**Hallsville R-IV School District
Proposition 2**

**Primary School
Gymnasium & Classroom Additions**

Progress Report #17
July 2020

S. M. Wilson & Co. has submitted Change Orders #41 through #45. We have listed a summary of each change order below. Please review each change order and let me know if you have any concerns.

ROOF PLAN 'B' - DEMOLITION
3/32" = 1'-0"

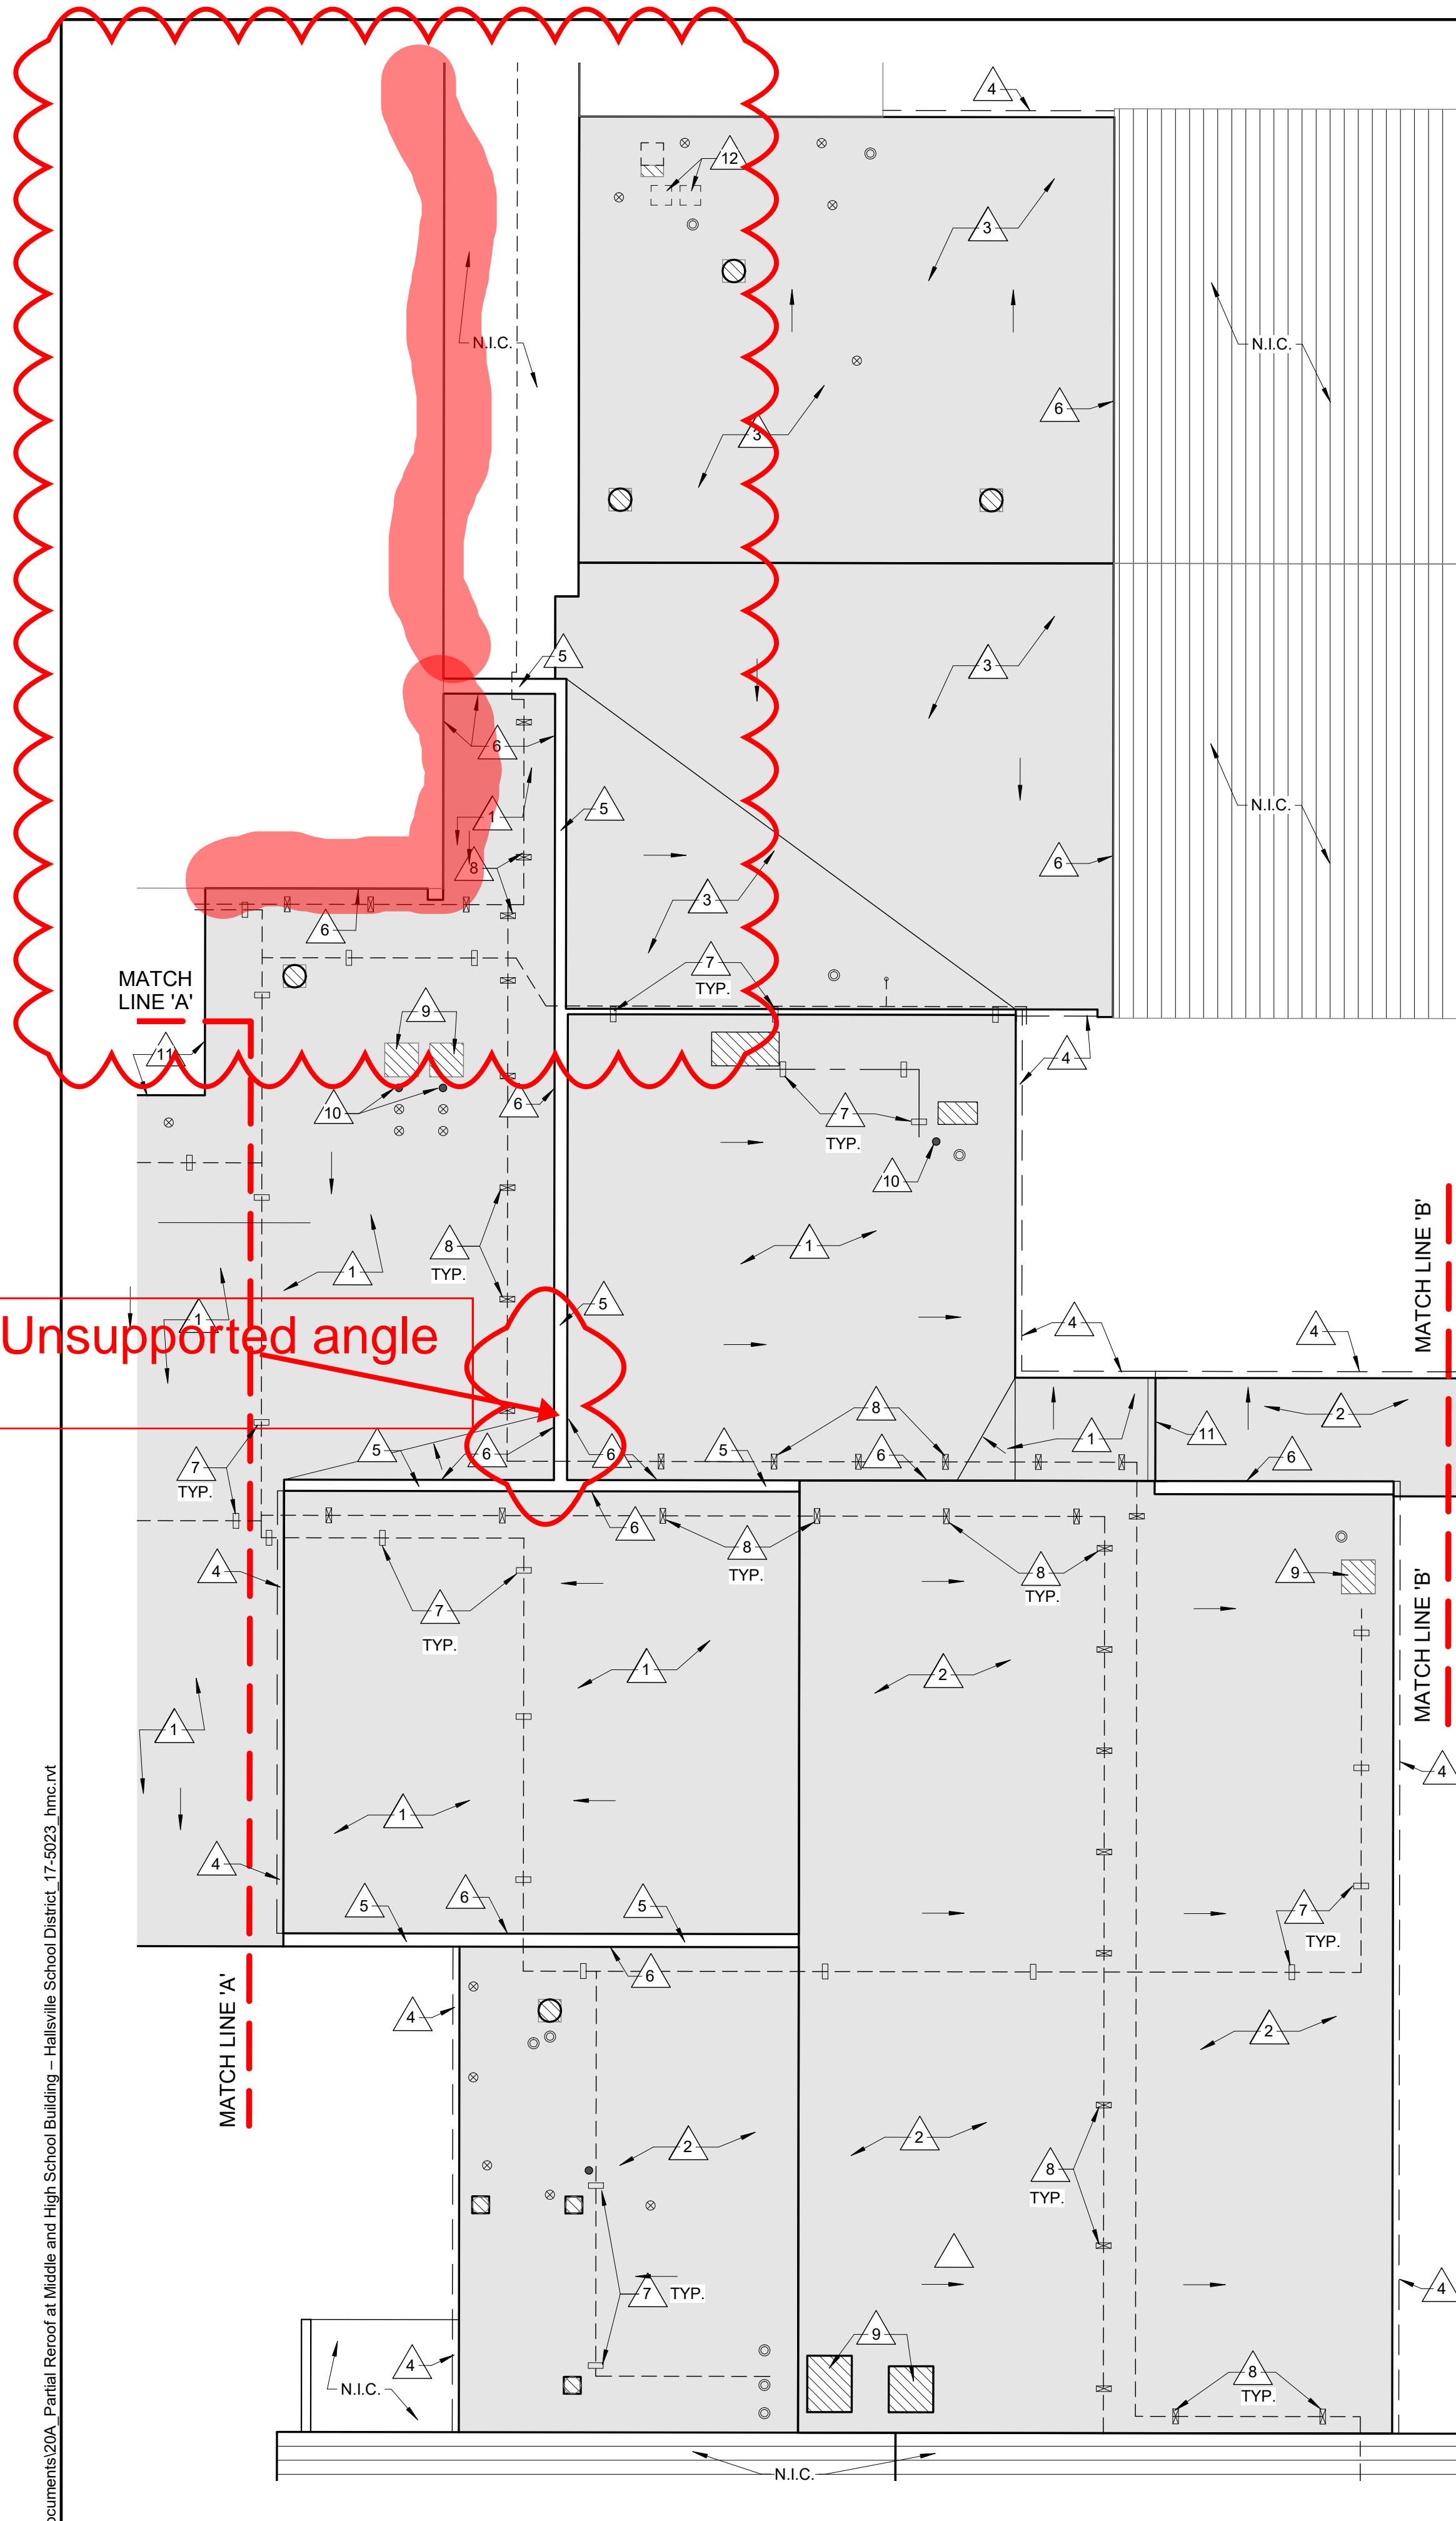
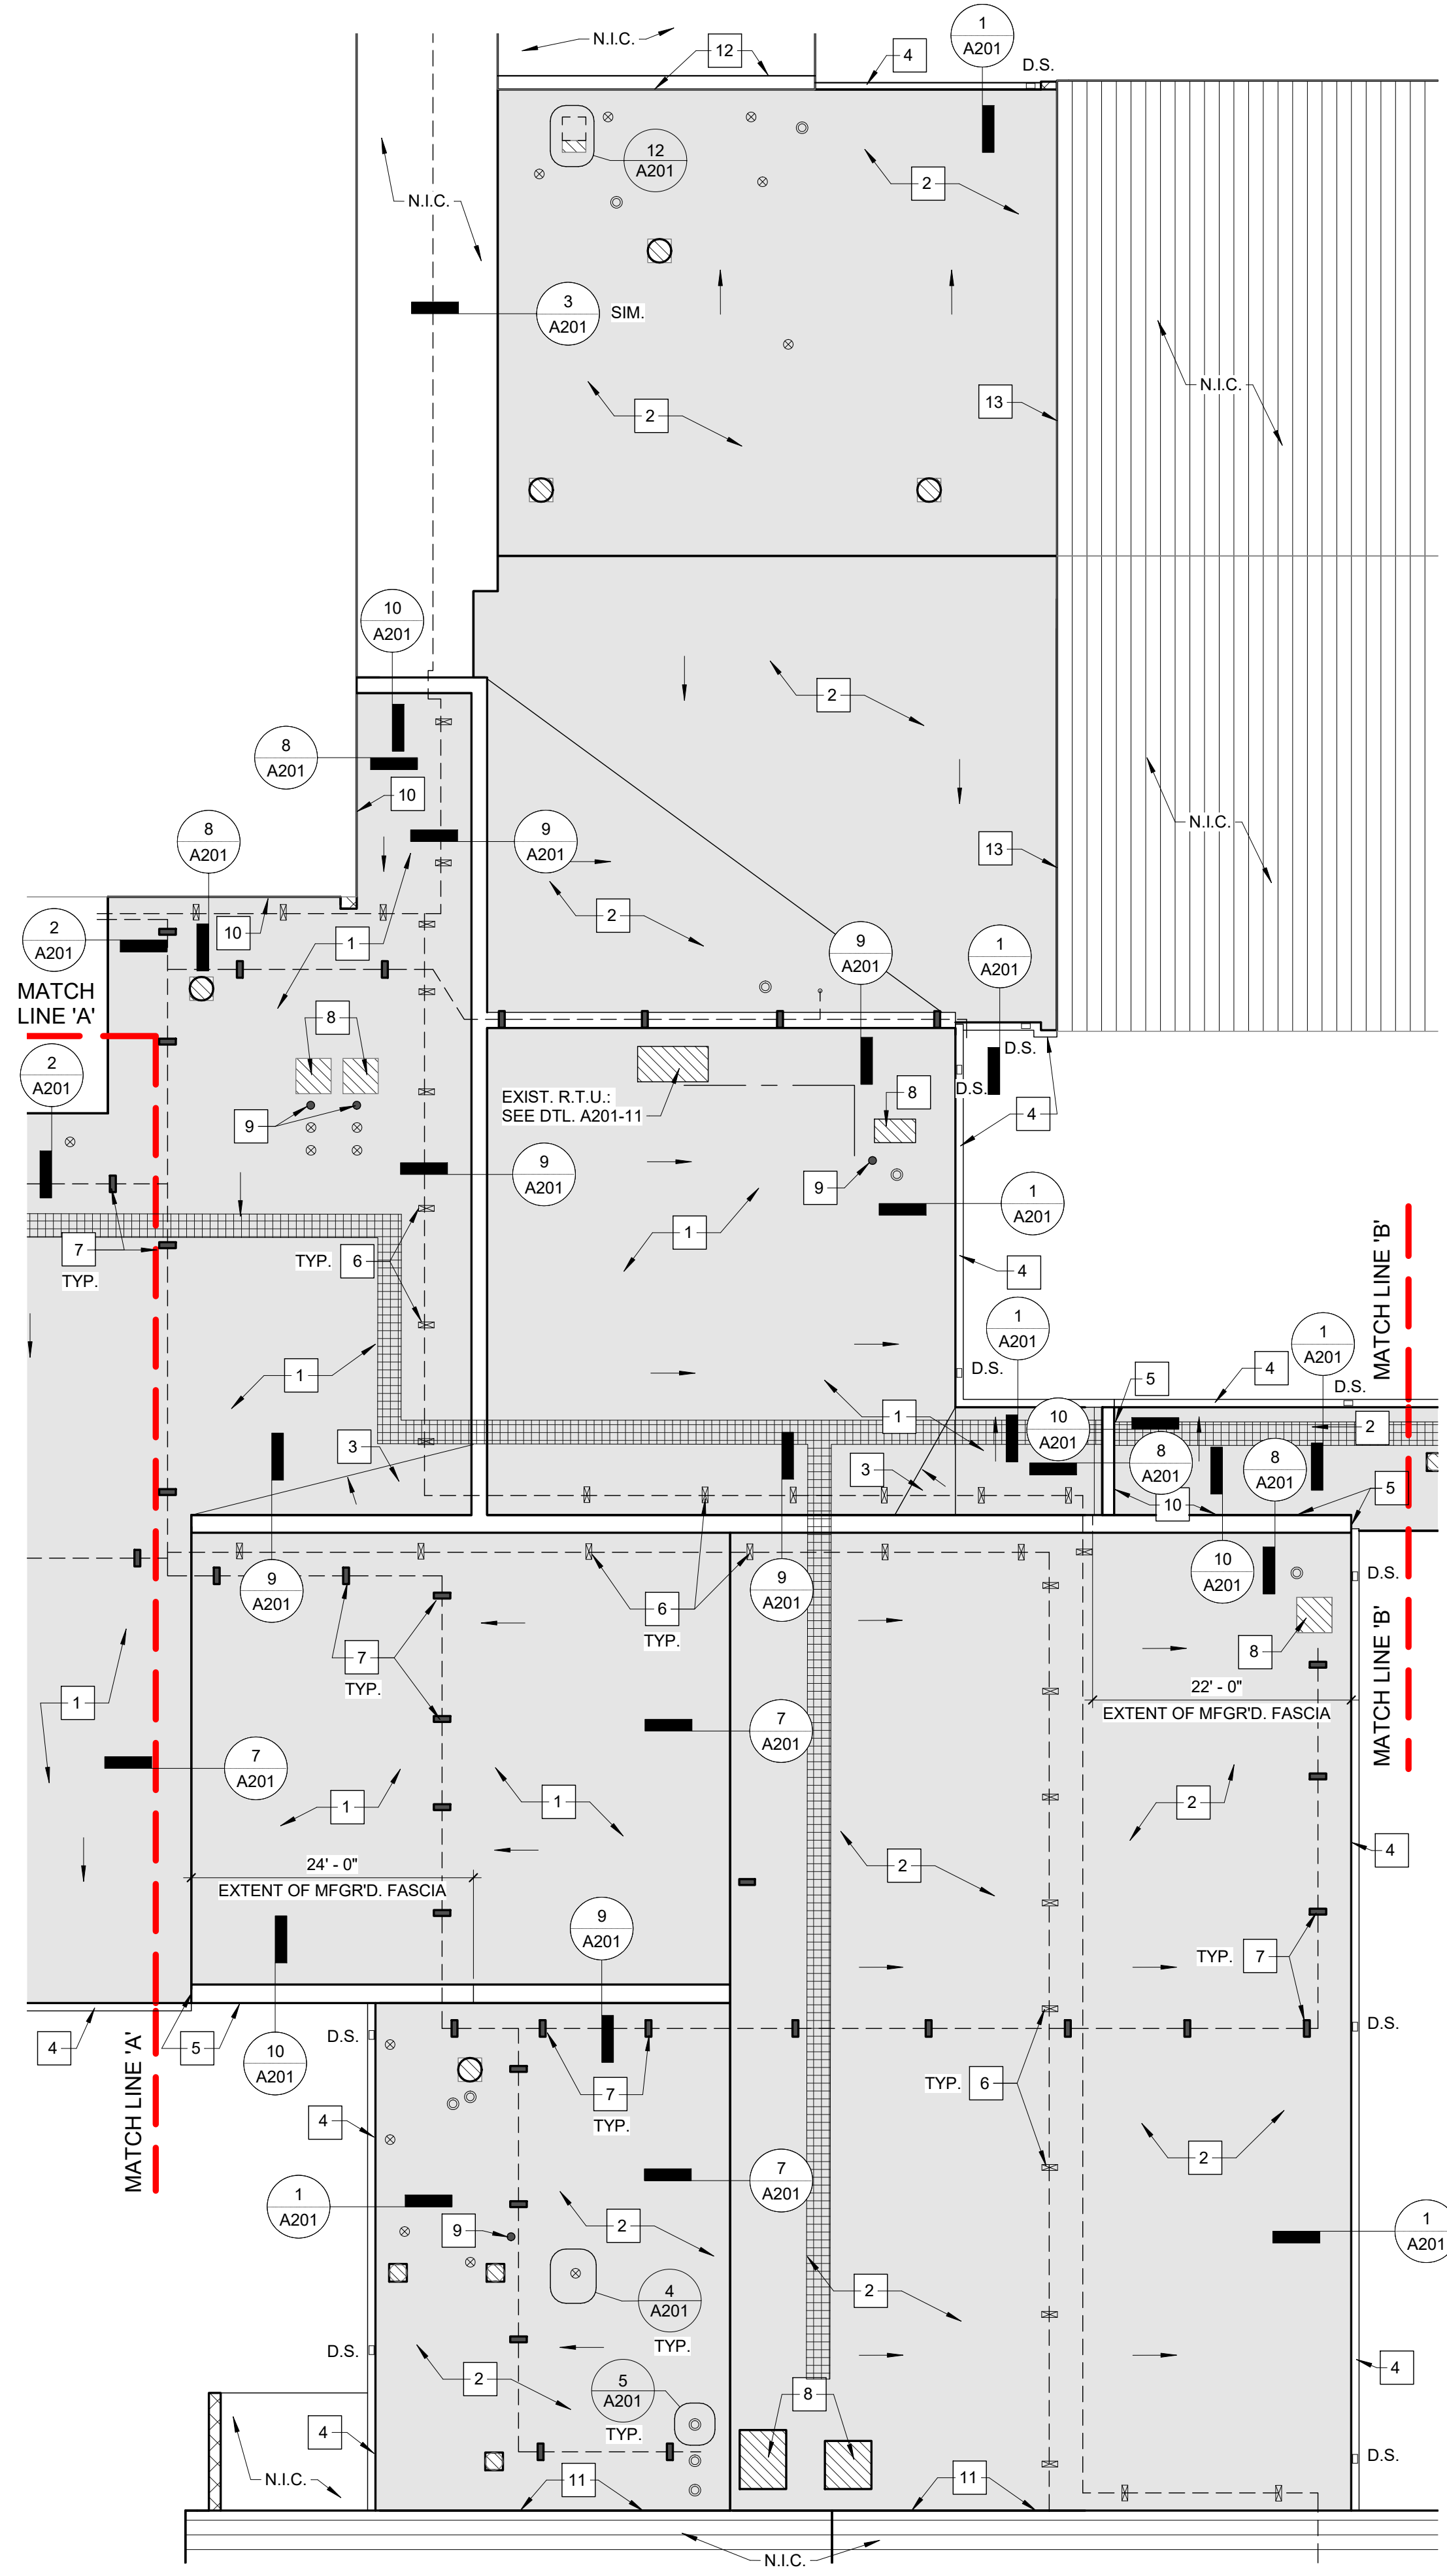
Please find enclosed a change order request for furnishing and installing 3x3 angles at the re-roofing project. Existing steel angle was found to be unsupported and RFI 120 was issued to Klingner for guidance. The angles were added as a result of that request for information. We have reviewed this request and are in agreement that the costs are appropriate for the changes being incorporated into the project.

Confirming RFI. Reference attached plan mark up. The highlighted areas show where steel angle is unsupported and the question to Klingner was how to support said angle.

Based on phone call with Klingner: 3" x 3" 1/4" steel angle -Approximate length is 53" - Epoxy anchored Minimum size of anchor 5/8" spacing no more than 24". Plan to have 4 anchors.

12 ENLARGED RESTROOM PLANS-GYMNASIUM
1/4" = 1'-0"

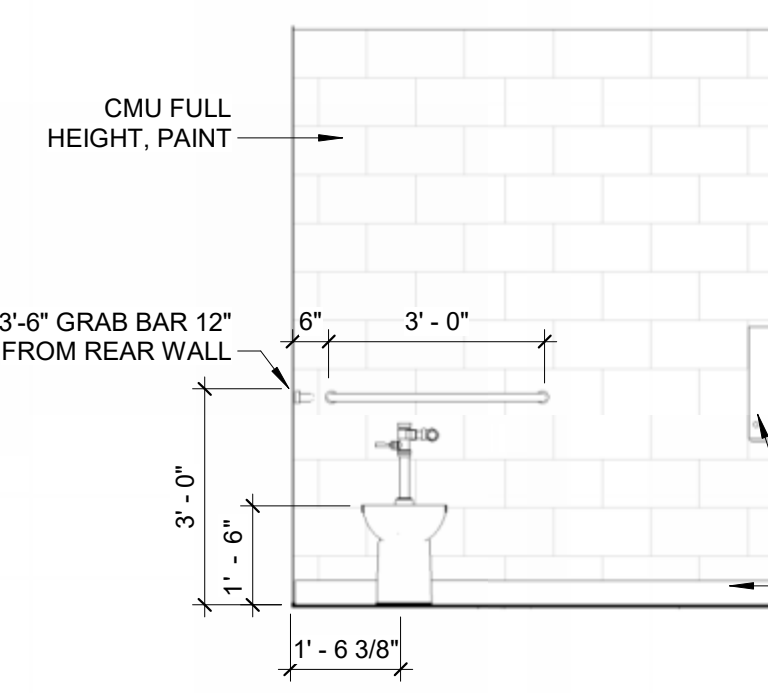
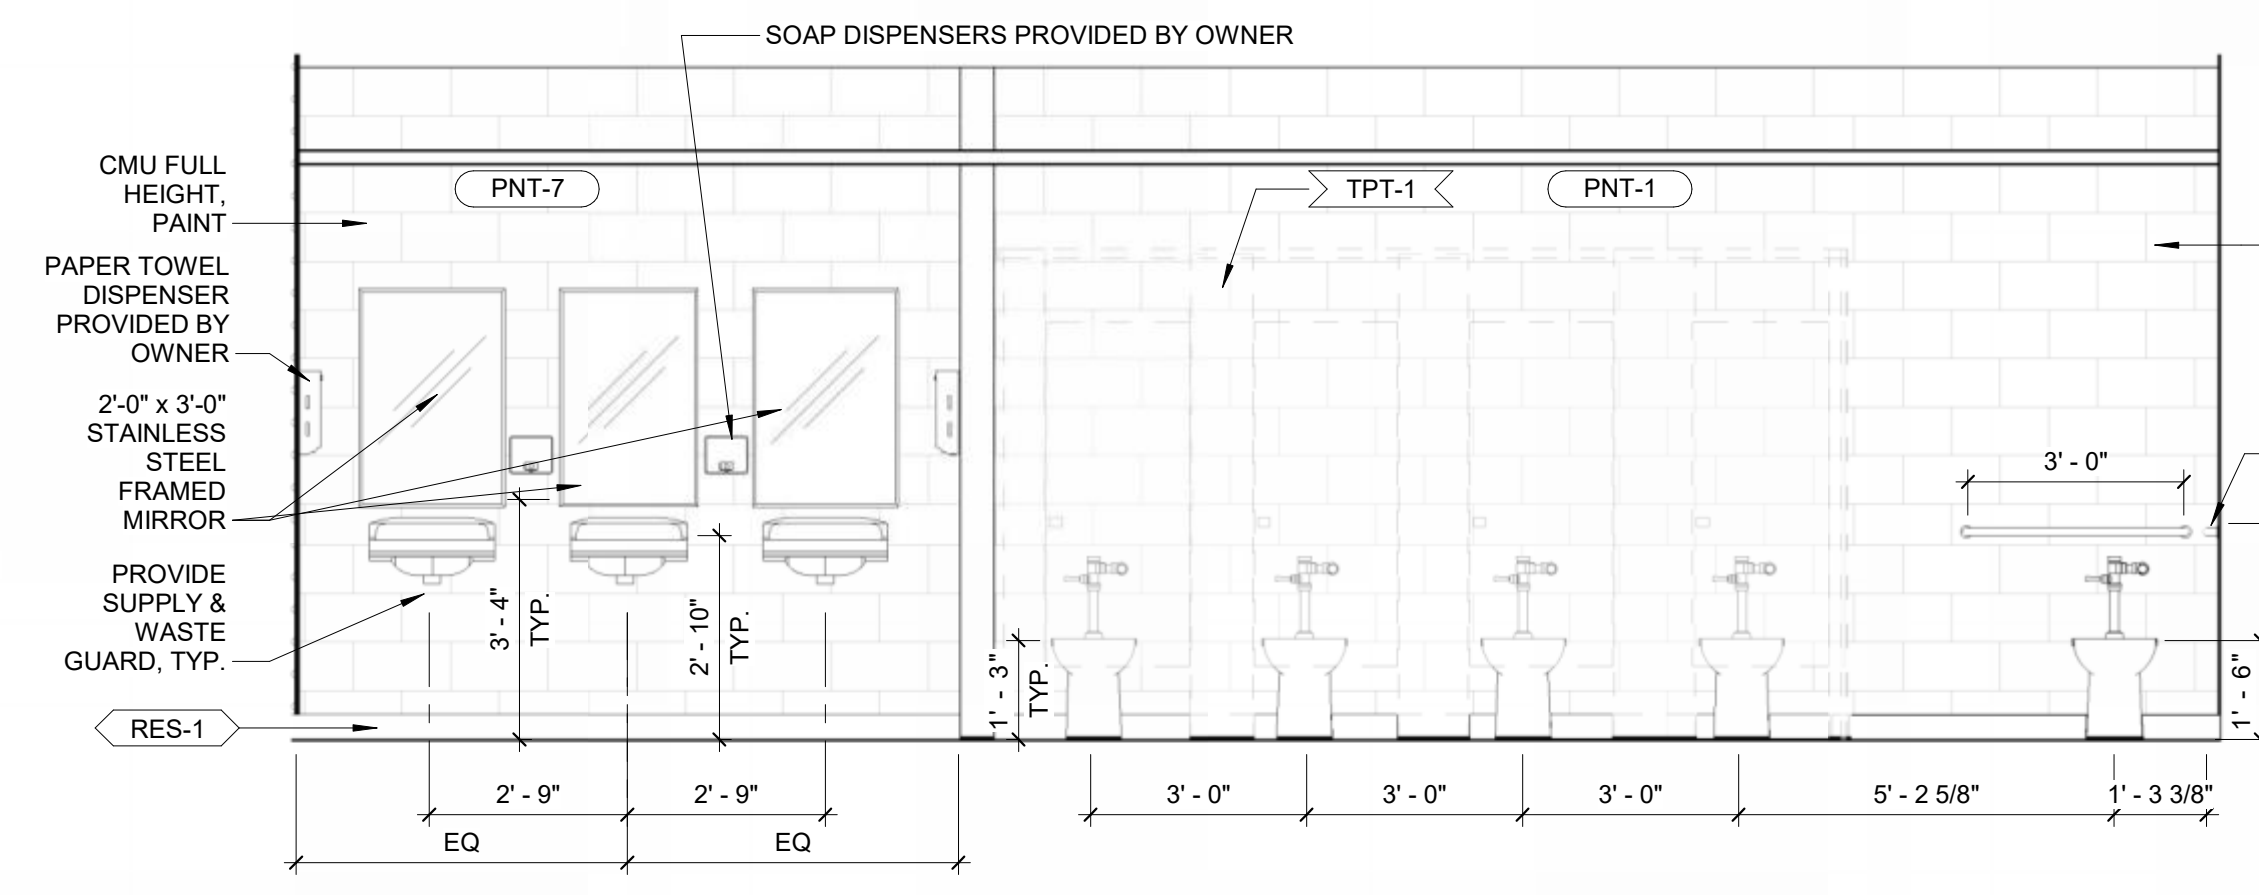
Please find enclosed a change order request for furnishing and installing electrical modifications for added hand dryers in the restrooms. Reference RFI 122 response. We have reviewed this request and are in agreement that the costs are appropriate for the changes being incorporated into the project.

The District would like to install hand dryers in the new restrooms and locker rooms. The type will be Xlerator XL-GR1.1N High Speed Commercial Hand dryers. Reference attachment for locations (most will be surface mounted). Please advise on circuits that can be used to feed the hand dryers.

Hand Dryer's

Description	Net Amount
Meyer Electric	
Additional work on site to furnish and install electrical modifications for electric hand dryers in the restrooms. Reference RFI 122 response. Conduits will be run exposed along the face of the walls. Please note this cost does not include the hand dryers as those are being purchased by the School directly.	5,822.00
Each hand dryer shall have their own dedicated 20A circuit breaker. The assigned slots are as followed:

3) The four hand dryers in Boys 109 and Girls 108: Install in slots 35,37,39 and 41 of Panel-LA3 in Corridor A115 of existing building.	
Owner's Contingency	
This change is to be funded from Owner's Contingency.	(6,315.85)
Subtotal:	\$(493.85)
SDI (Subcontracts):	\$72.78
SDI (Purchase Orders):	\$0.00
Performance & Payment Bond:	\$63.17
General Liability:	\$63.16
FEE:	\$294.74
Total Cost:	\$0.00
